CONTRACT CHANGE ORDER NO. _____
SHEET ____ OF ____

REQUESTS FOR INFORMATION NOT ADDRESSED IN THIS CCO REMAIN IN FORCE					
1	02/10/11	BRACKETS FOR FUTURE LIGHT PIPES	TS	JB	182
MARK	DATE	DESCRIPTIONS	BY	CH'D	CCO#
REVISIONS

DETAILS
SAS SUPERSTRUCTURE ROADWAY WESTBOUND
TYPICAL LIGHT PIPE INSTALLATION 1

SAN FRANCISCO OAKLAND BAY BRIDGE
EAST SPAN SEISMIC SAFETY PROJECT
SELF-ANCHORED SUSPENSION BRIDGE
(SUPERSTRUCTURE & TOWER)

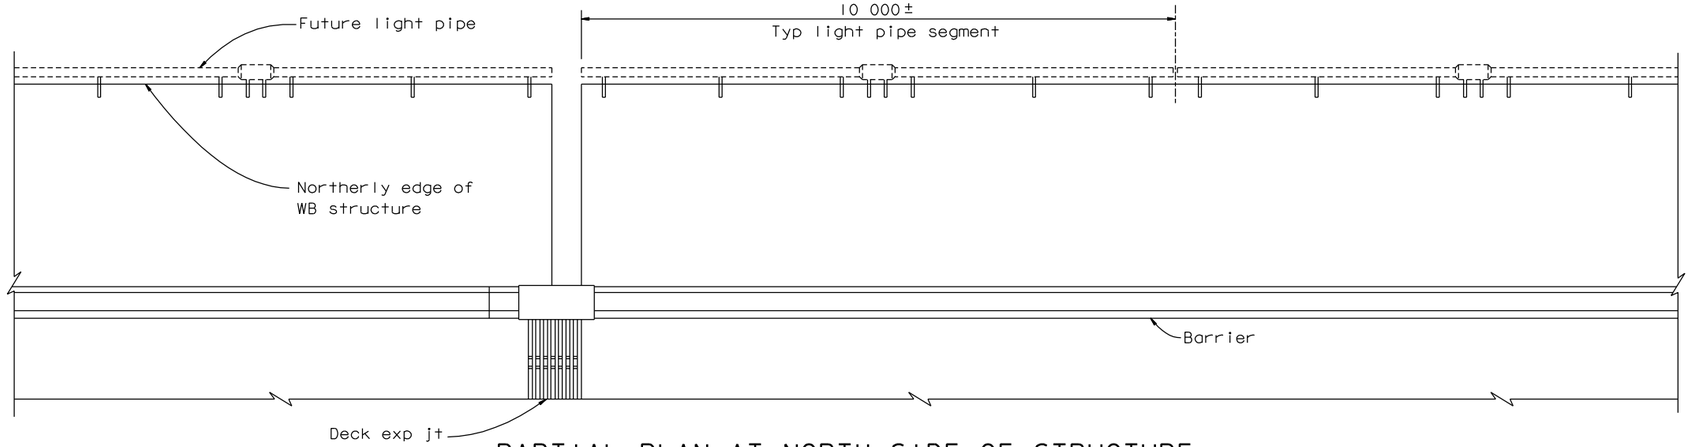
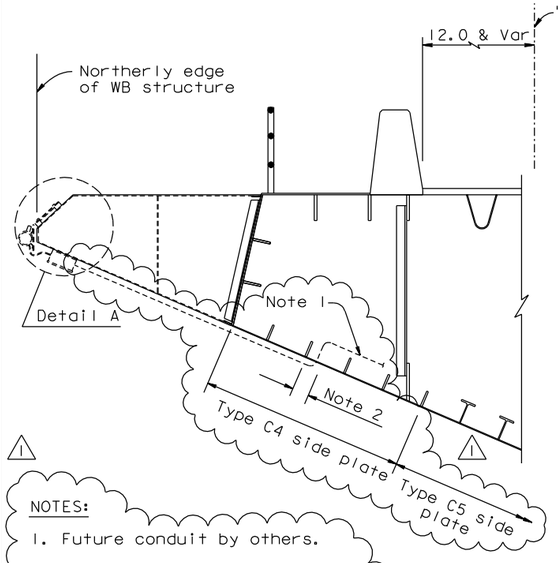
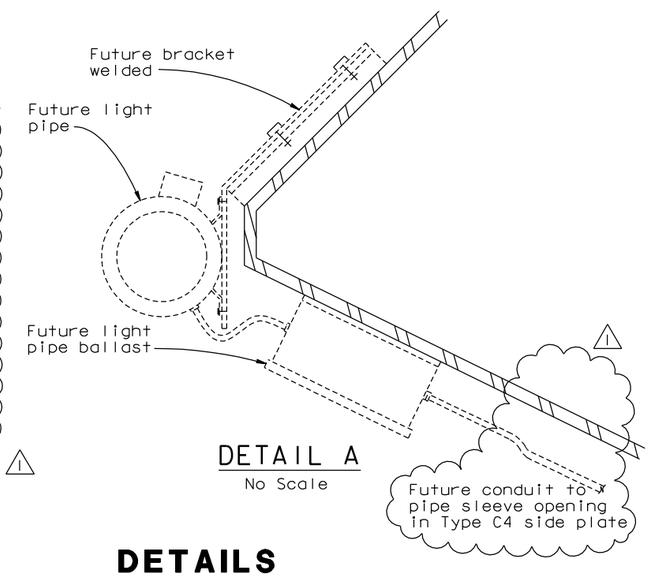
1. Future conduit by others.
2. 51 mm diameter pipe sleeve is located 100 mm from the 2nd stiffener toward the 3rd stiffener and 1000 mm West of even panel point. If splice of side plate C4 is near the West of even panel point, locate the hole 1000 mm East of even panel point.

DETAILS
SAS SUPERSTRUCTURE GIRDER EASTBOUND
TYPICAL LIGHT PIPE INSTALLATION 1

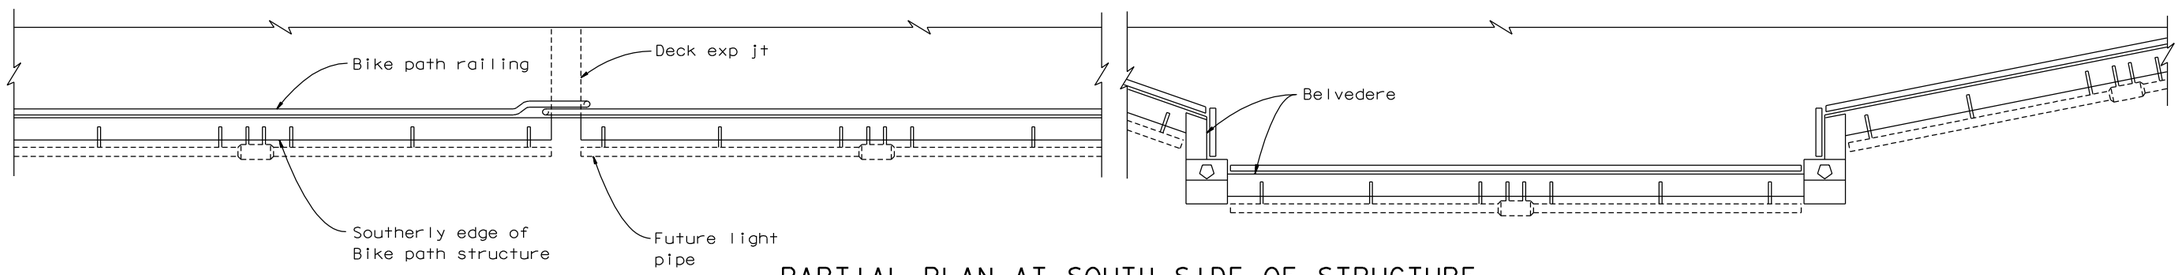
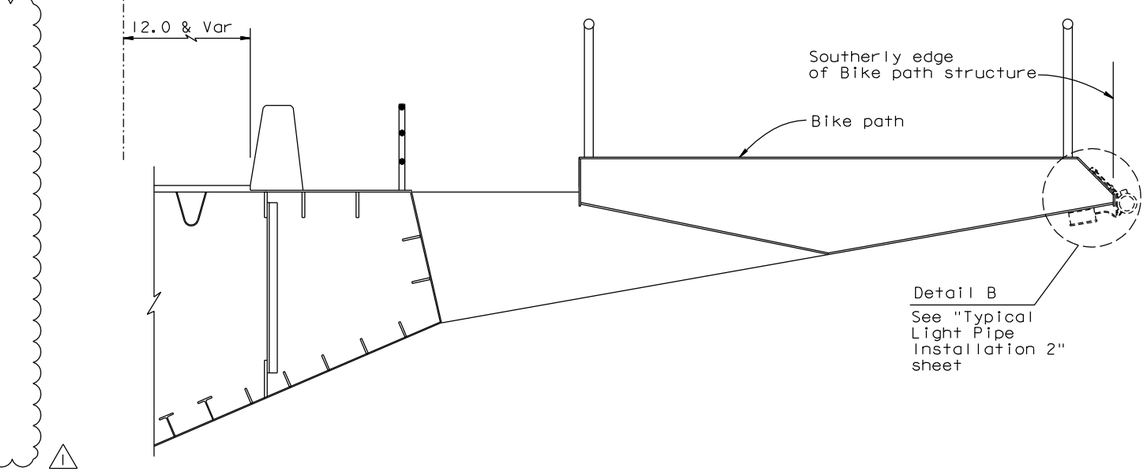
MARK	DATE	DESCRIPTIONS	BY	CH'D	CCO#
1	02/01/11	BRACKETS FOR FUTURE LIGHT PIPES	TS	JB	182

LIGHTING DETAILS NO. 2

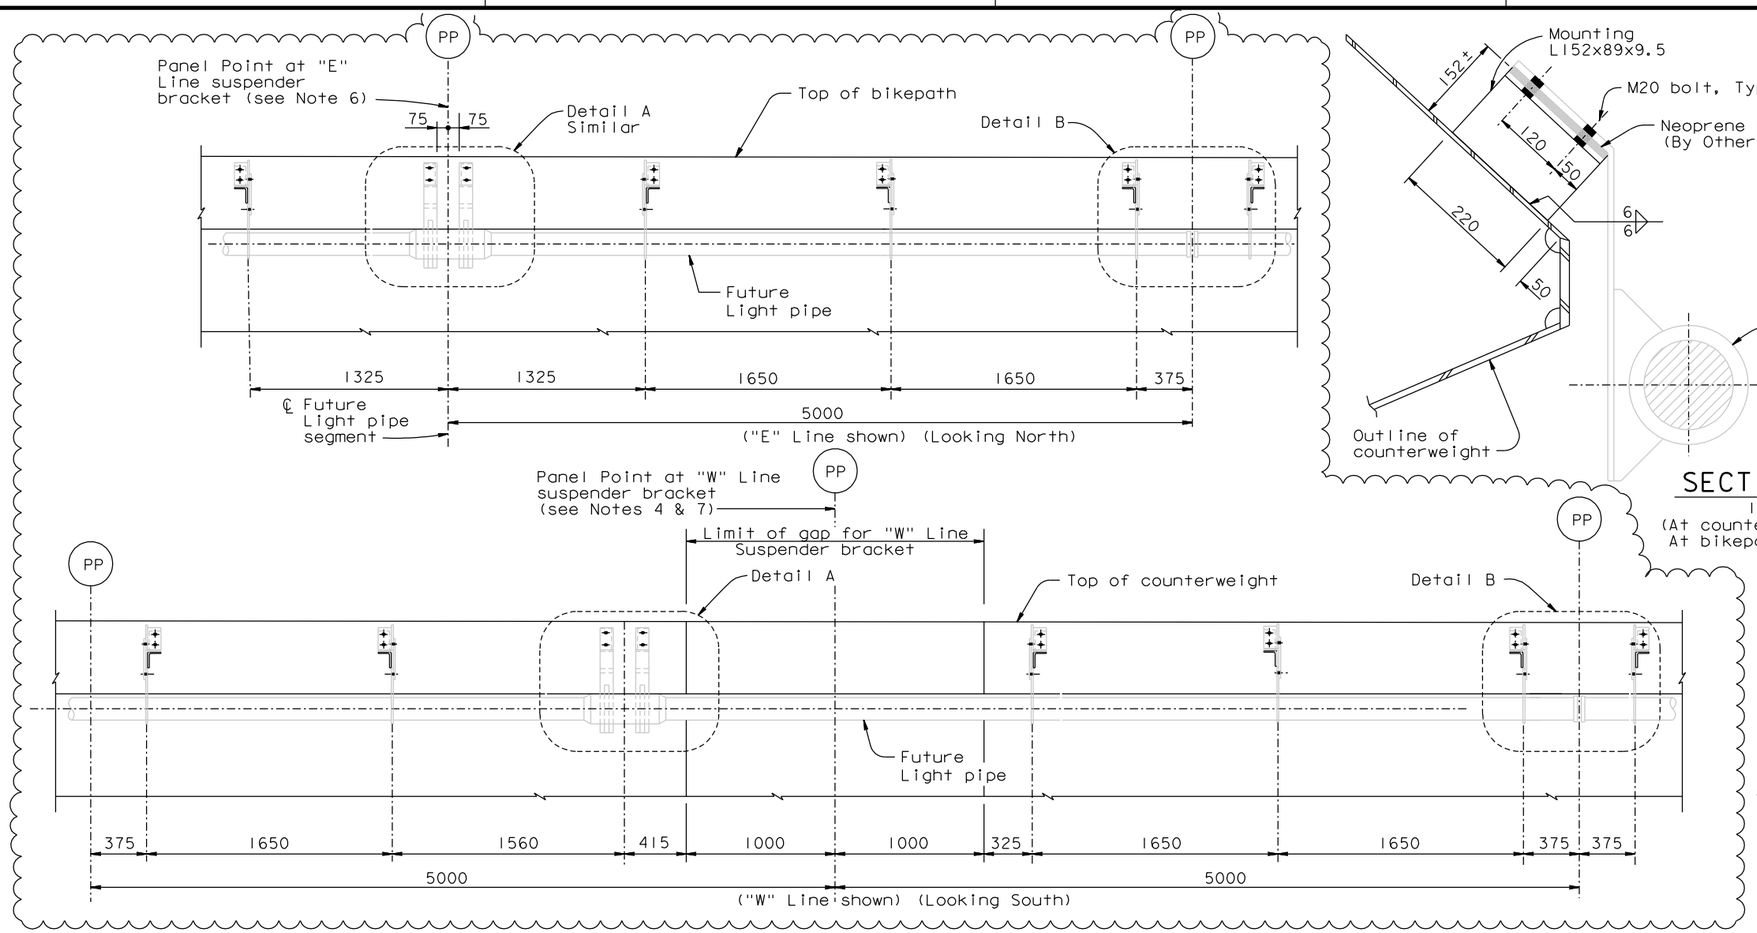
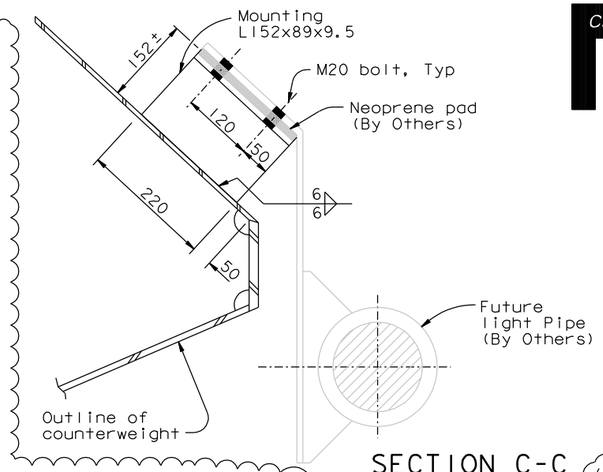
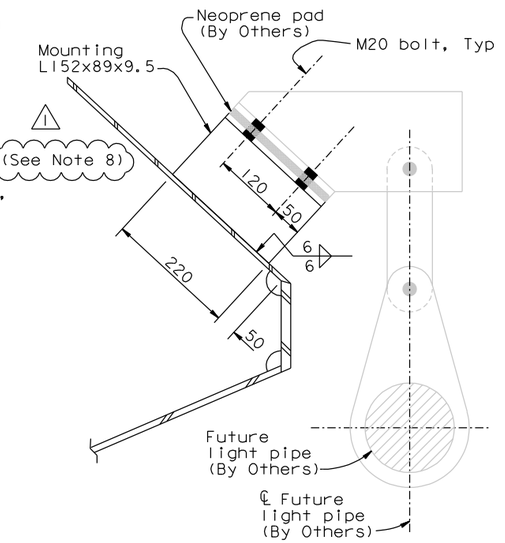
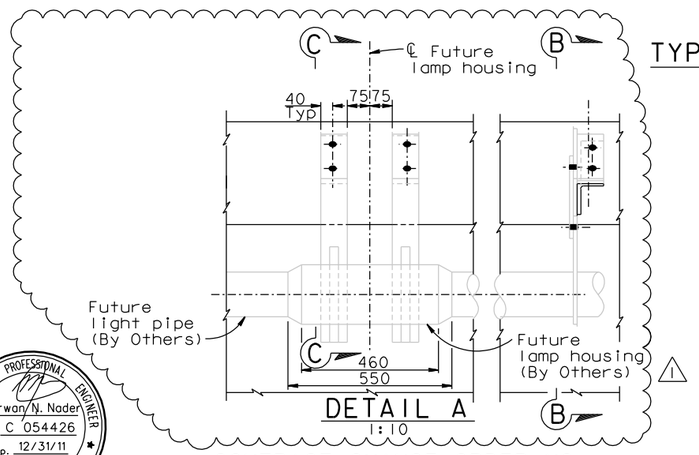
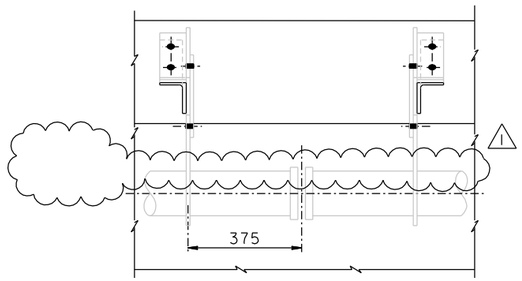
1. Details shown for counterweight side. Bikepath side similar.
2. Mounting angles shall be installed. Future light pipe and appurtenance by Others.
3. Provide all bolts to be installed in open holes.
4. Support for future light pipe is shifted to avoid counterweight gap.
5. Future light pipe support spacings are taken to the back of the mounting angles.
6. Provide future lamp housing brackets at even panel points 6 through 126.
7. Provide future lamp housing brackets at even panel points 8 through 104.
8. For mounting bracket removal procedures, see "Lighting Details No.3" sheet.

MARK	DATE	DESCRIPTIONS	BY	CH'D	CCO#
1	02/10/11	BRACKETS FOR FUTURE LIGHT PIPES	GB	MN	182

LIGHTING DETAILS NO. 3

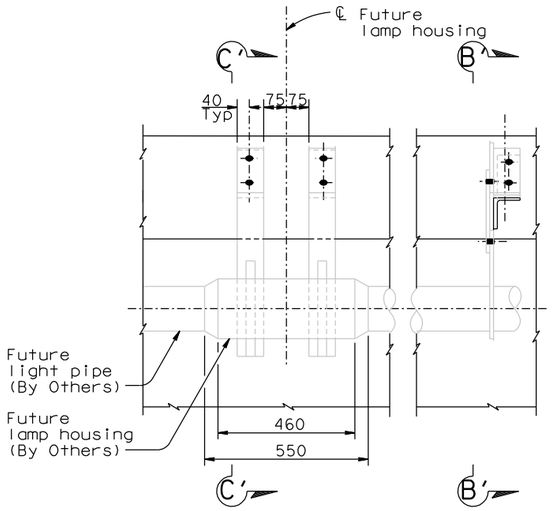
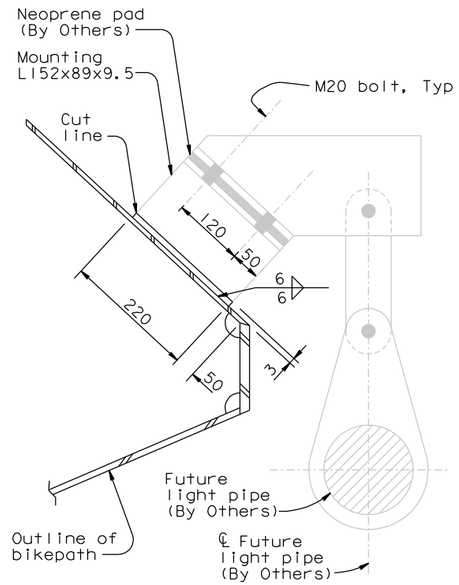
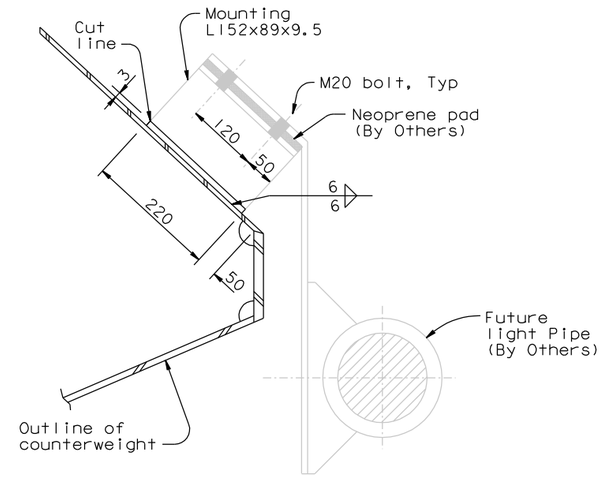
REMOVAL OF BRACKETS FOR FUTURE LIGHT PIPES

MARK	DATE	DESCRIPTIONS	BY	CH'D	CCO#
0	02/10/11	BRACKETS FOR FUTURE LIGHT PIPES	JD	MN	182

1. Cut mounting bracket a distance of 3 mm from bikepath or counterweight, or as otherwise approved by the Engineer.
2. Grind angle down flush with bikepath or counterweight.
3. Clean and paint bikepath or counterweight.
